Nine Mile Point Unit 1
Docket No. 50-220
DPR-63
TAC No. M83486

Elastic Plastic Fracture Mechanics

Assessment for Nine Mile Point Unit 1:

Response to NRC Request for Additional Information

Figure 2.1-1
 Comparison of J_e -R Curves for A302B Plate
 (Data Taken from [HI89])

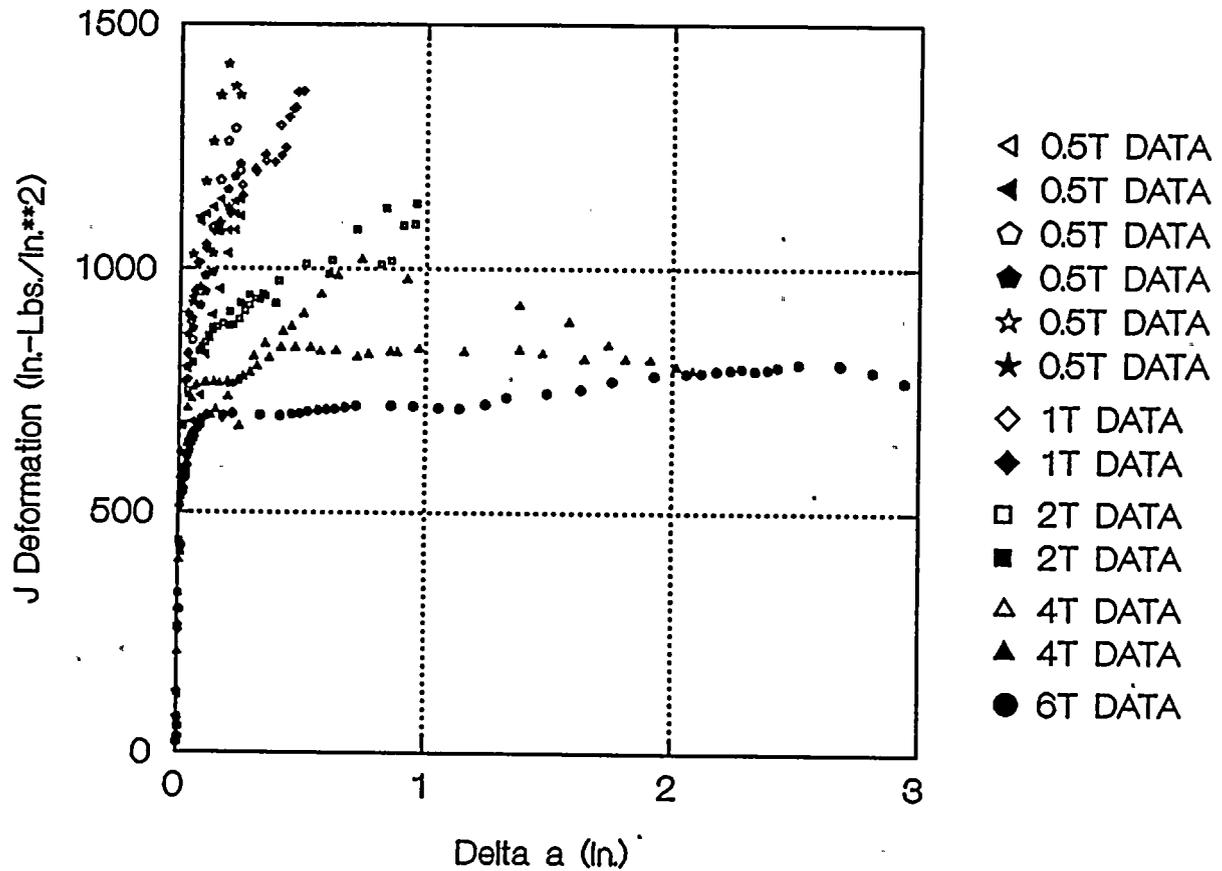
"The report indicates that the J-R curve for a 6T specimen tested at 180°F is drawn to meet the J axis at $J_{IC} = 525 \text{ in-lb/in}^2$, then this curve is shifted down to make the J point coincide with the estimated J_{IC} point, leaving the difference between the plateau level of J and J_{IC} constant at 175 in-lb/in^2 , independent of both temperature and USE. Provide justification for the asserted independence of the J difference (175 in-lb/in^2) with respect to temperature and USE values. Also justify that the proposed J-R model should breakdown when USE values reach zero. (Although this issue was addressed in a telephone conference held in January 1993, a written response is required.)"

In contrast with the J-R curve data trends for other pressure vessel materials, Reference [HI89] reported an unprecedented size effect for A302B steel. As shown in Figure 2.1-1, the thicker the specimen, the lower the J-R response level after initiation. While similar data trends have been observed for some pressure vessel materials, decreases in the J-R curves of the magnitude reported by Hiser have not been reported earlier. Based on chemical and microstructural considerations, it was determined that the modified A302B (A302M) NMP-1 plates would exhibit ductile fracture behavior similar to that presented in Reference [HI89]. Reference [HI89] reported J-R data for 0.5T, 1T, 2T, and 4T specimens, but only one 6T test was performed (180°F, T-L orientation).

The micromechanical explanation for the J-R curve behavior shown in Figure 2.1-1 has not been definitively established. Hiser [HI89] has reported brittle-like splits, or laminate tearing, for all of the specimens tested. These splits are oriented in the direction of crack growth with small amounts of microvoid coalescence in the region between the splits. The size, relative number, and distribution of the splits are approximately constant for various specimen sizes. Hiser concluded that the splits resulted from separation of the interface between the material matrix and the inclusions (sulfides, aluminides) and/or the splitting of the more brittle alloy rich bonded structure (possibly bainite). The only apparent difference in the fracture of small and large specimens is the total number of splits and not the relative proportion. A complete micromechanical explanation is not yet available.

Figure 3.7-1
 Equivalent Line Load Stress Intensity Factor Equation

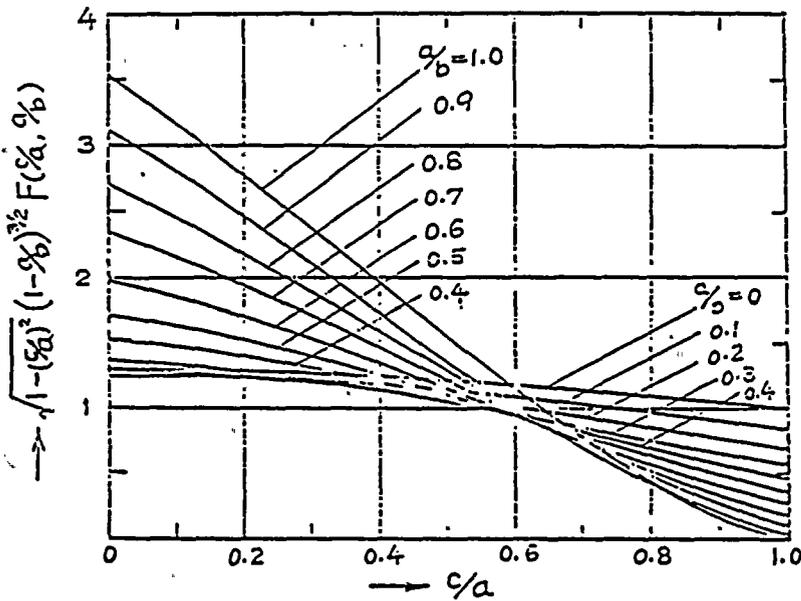
"Provide the derivation or the reference (indicating the page number) of Equation (5-3)."

Equation 5-3 of Reference [MA93b] can be found in the following reference:

The Stress Analysis of Cracks Handbook, Tada, H., Paris, P., Irwin, G., Del Research Corporation, June, 1973, page 2.27

A copy of the Tada model is shown in Figure 3.7-1.
